## Changes in the axis sleeves of caster fork on Agile

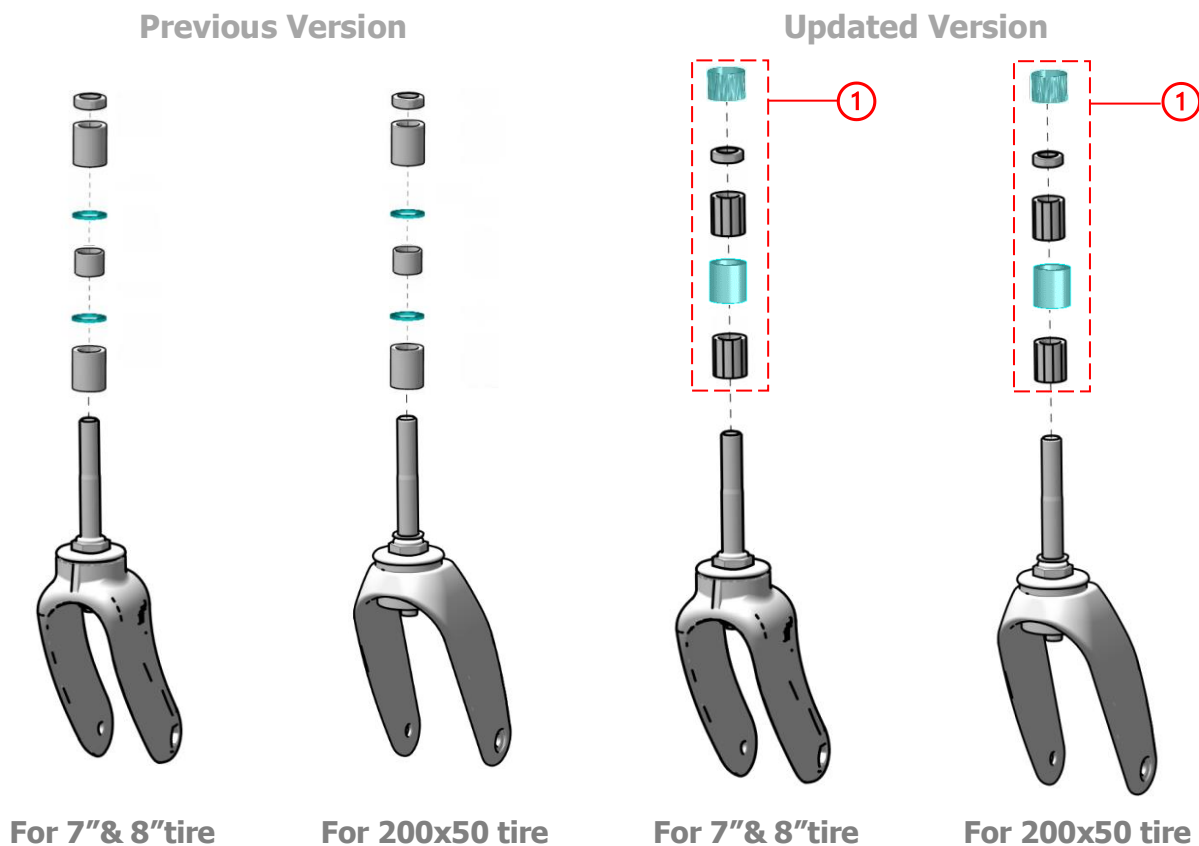
- ✓ To improve the tightness between the caster fork axis and side frame on Agile, Karma has changed the design of the axis sleeves as follows:
  1. Two flat washers have been removed from the axis sleeves kit.
  2. The material of the middle axis sleeve has been changed from aluminum to plastic.
  3. The new anti-slip plastic sleeve has been added on the nut that secures the top of the caster fork axis.
- ✓ From now on, please order the new sleeves kit ① when repairing the front caster fork.
- ✓ The updated version is backward compatible with the existing one.
- ✓ The updated version was implemented by the batch of serial no. HM22-025623, not including HM22-27390~HM22-27404, HM22-27375~HM22-27389 and HM22-27675~HM22-27704.
- ✓ The updated version was implemented on Agile.
